5.4 T200500-1 APP – application to amend planning permit T200500 that allows for the use and development of a place of worship and associated works to delete requirements of condition 1

That a Notice of Decision to grant Planning Permit application T200500-1 be issued to delete requirements of condition 1 (d) (ii), (vi) and (vii) of the permit at L1 LP140615, Army Road, Pakenham VIC 3810.

APPLICATION NO.:	T200500
APPLICANT:	Natalie Gray
LAND:	L1 LP140615, Army Road (Corner of Murphy Road), Pakenham VIC 3810
PROPOSAL:	Deletion of condition 1 d) ii, vi and vii of planning permit T200500
PLANNING CONTROLS:	General Residential Zone – Schedule 1 Development Contributions Plan Overlay - Schedule 1
NOTIFICATION & OBJECTIONS:	Notices sent to owners and occupiers of adjoining properties. Two (2) objections were received.
KEY PLANNING CONSIDERATIONS:	Neighbouring amenity
RECOMMENDATION:	Notice of decision to grant a permit

Figure 3: Amended landscape plan (current)

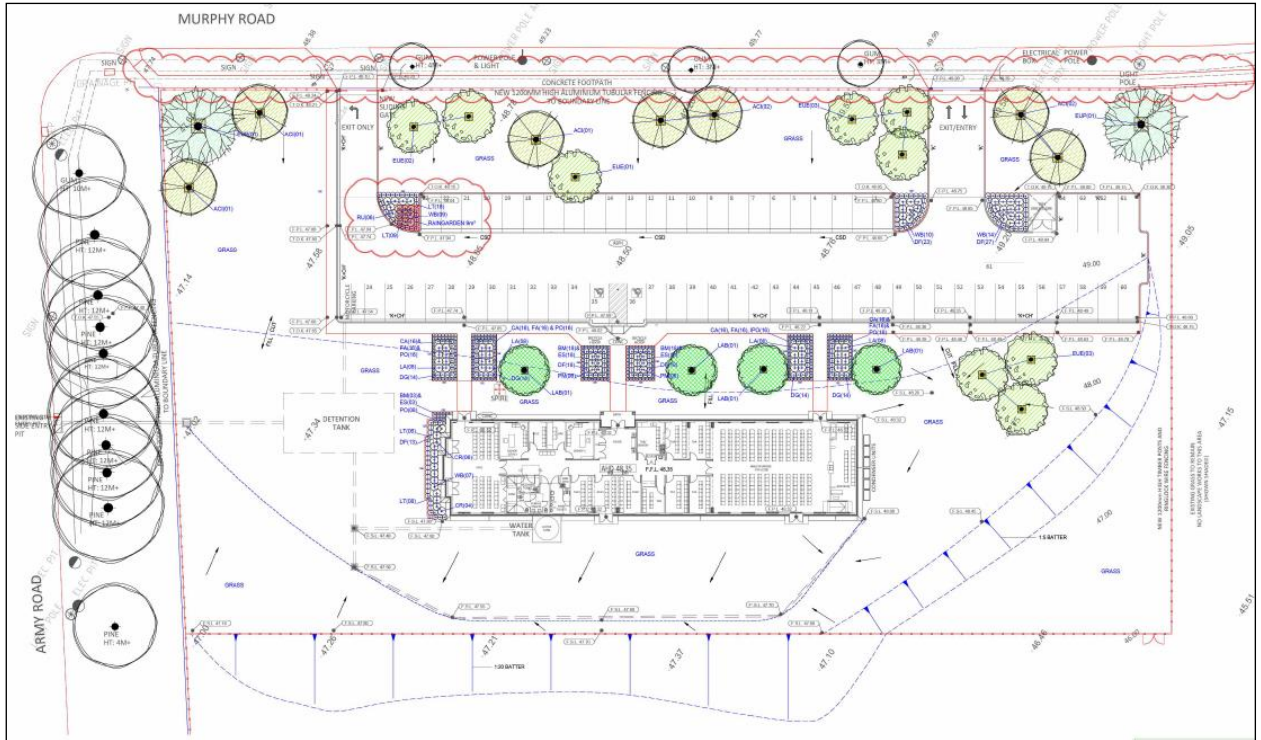
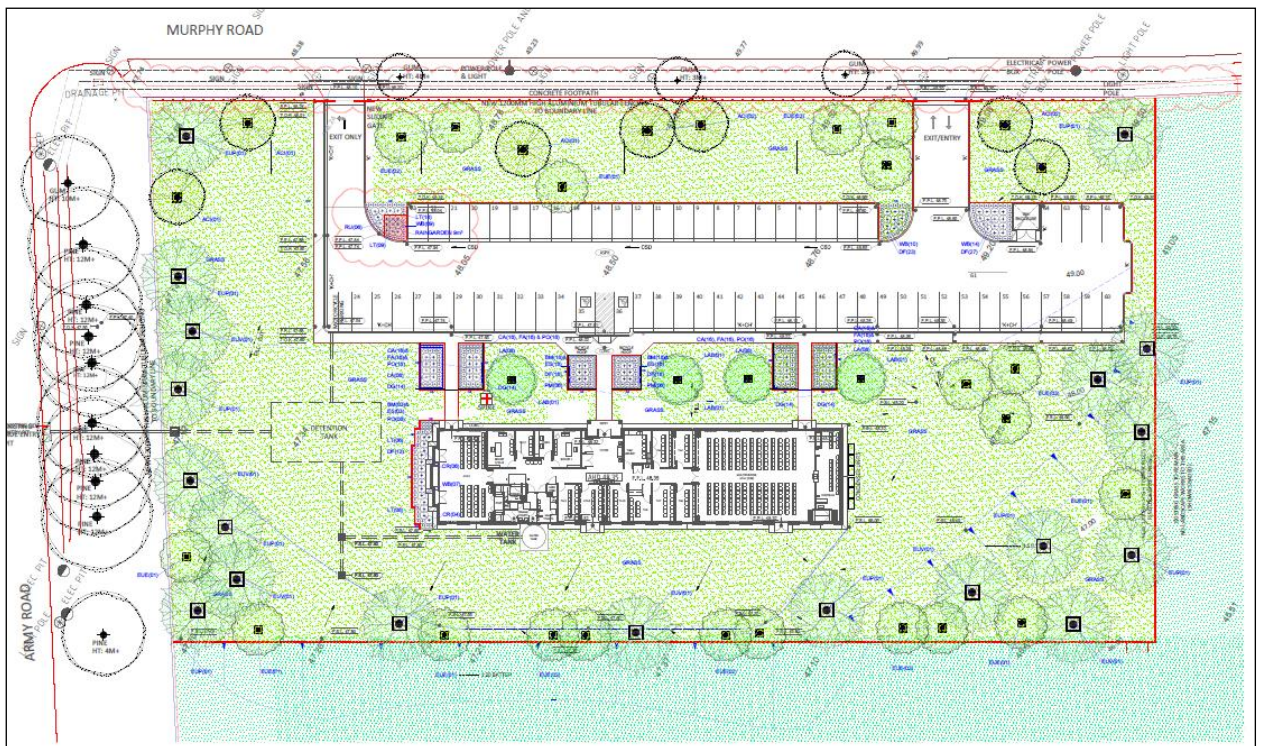
The reasoning set by the applicant for the deletion is that the requirements are disproportionate to the scale of the proposal and the area that the works occupy relative to the size of the property. The applicant instead seeks to contain landscaping to the 'development area' only, defined by the internal fencing (shown in red on figure 2 below).

The amended landscape plan was submitted to the Parks and Gardens department for review. The initial landscape plan (figure 2) limited landscaping to the northern frontage of the building along Murphy Road including a group of garden beds and scattered small to medium sized native trees.

The proposed changes were not supported by the department who identified the sensitive residential location and the likely future removal of the Army Road reservation trees that would result in very limited screening and softening of the built form from this aspect.

In response to the concerns raised by Council and two objections received during public notice, an amended landscape plan was submitted (figure 3) that has introduced landscaping along the west, south and east sides of the building and car park.

The Parks and Gardens department have reviewed the latest version of the plan and are satisfied with the additional landscaping and reduction in the distribution of planting proposed.

In response to the objections and Council concerns, the permit applicant has amended the landscape plan by broadening the distribution and increasing the volume of landscaping throughout the development area, particularly to the south-eastern aspect. A combination of Eucalyptus Viminalis, Eucalyptus Polyanthemos and Eucalyptus 'Euky Dwarf' have been selected along the southern and eastern interfaces that will provide visual screening at varying heights once mature.

As a consequence of the updated landscape plan, the landscaping will act to sufficiently minimise the visual impact imposed by the development from sensitive site interfaces with a suitable selection of shrubs, and a focus on medium and larger tree species that have greater longevity and potential for screening once mature.

PROJECT No.
89520
 SCALE
1:200
 DRAWING NUMBER
TPL01
 DRAWING TYPE
TOWN PLANNING

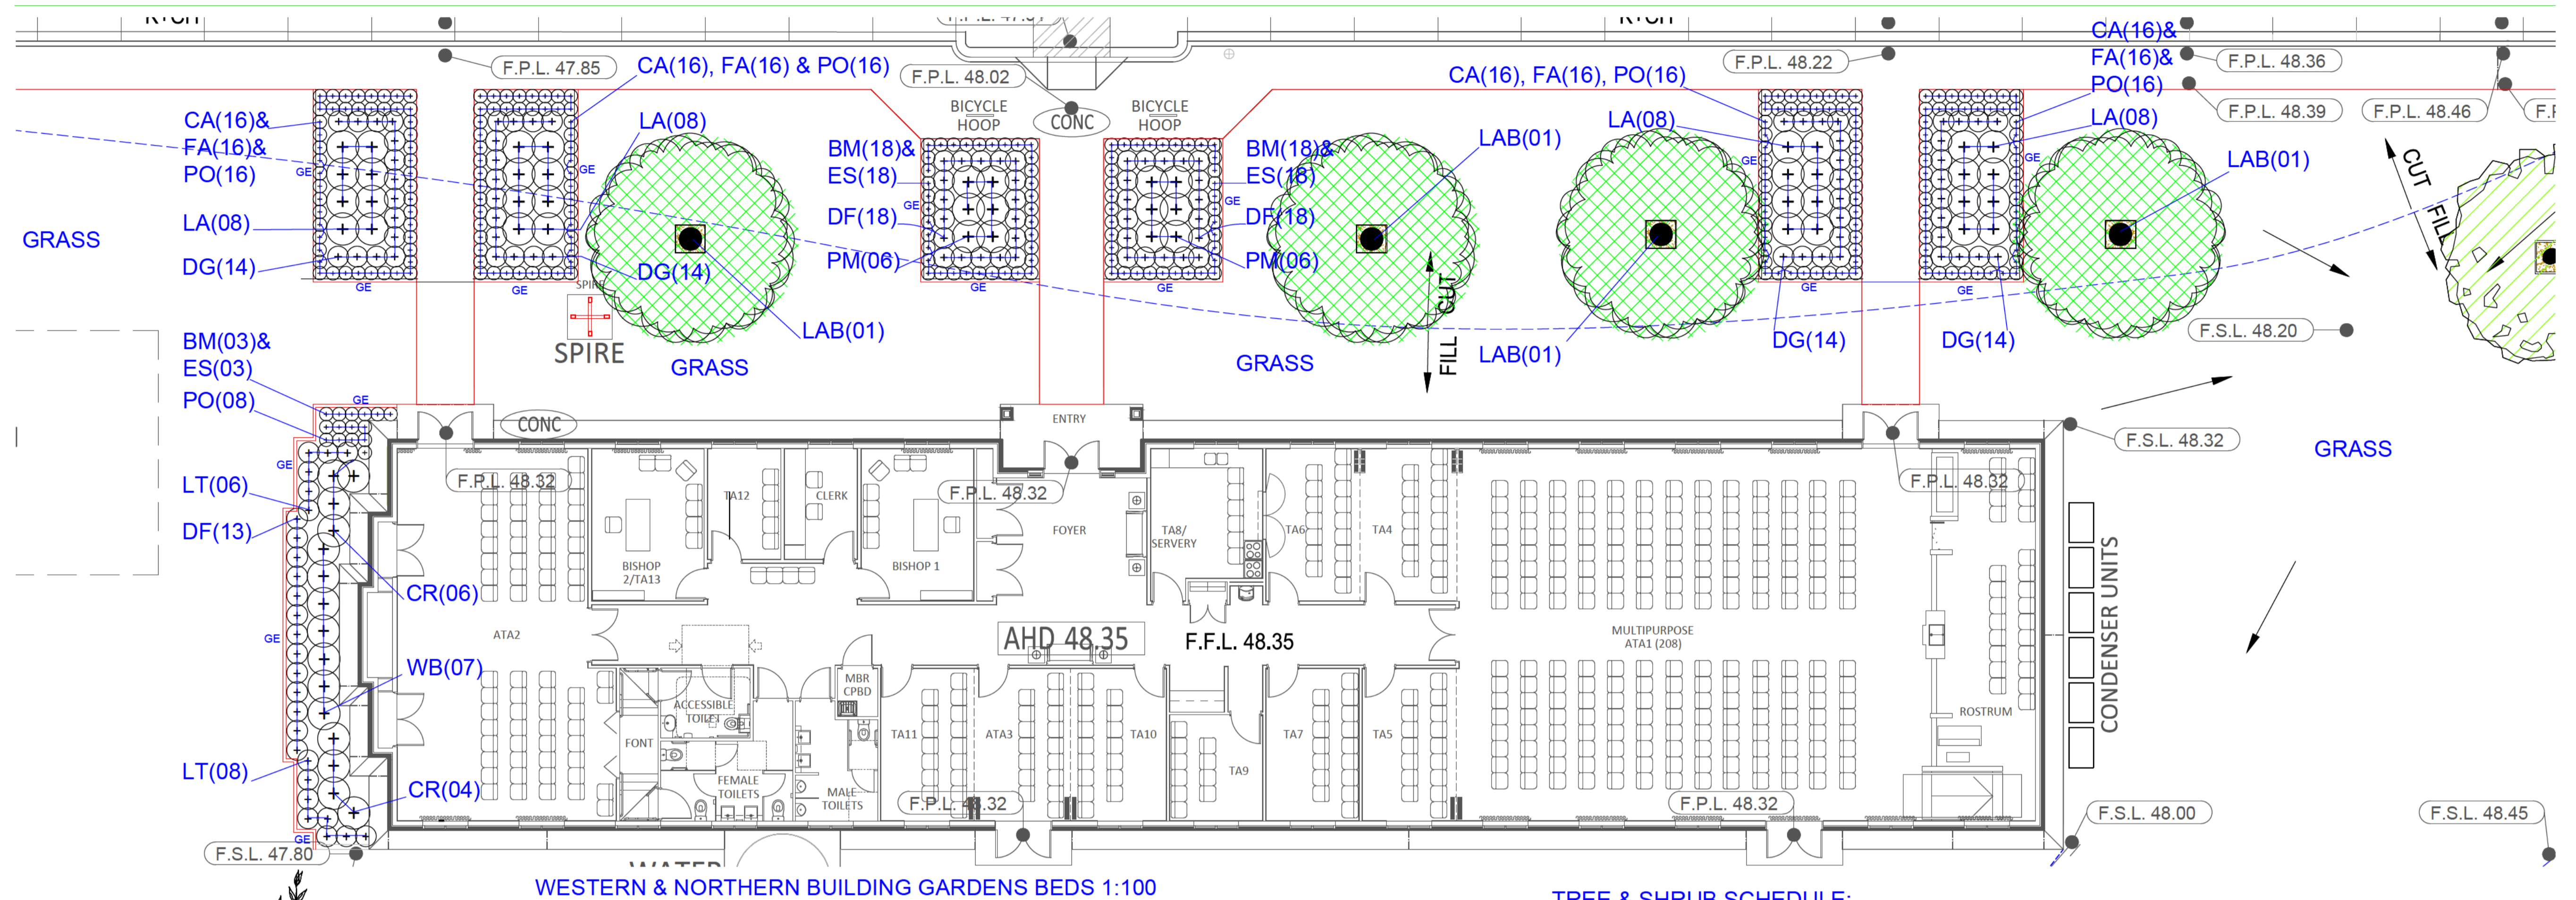
NO.	DATE	ITEM
E	20.05.21	ADDITIONAL TREES TO EAST, SOUTH & WEST
D	01.02.21	STREET FOOTPATH & RAINGARDEN & 1200 TREE SURROUNDS
C	08.10.20	CIVIL & LANDSCAPE REDESIGN
B	17.07.20	CARPARK REDESIGN - AMEND QUANTITIES OF TREES & SHRUBS
A	10.06.20	UPDATE NUMBER OF TREES
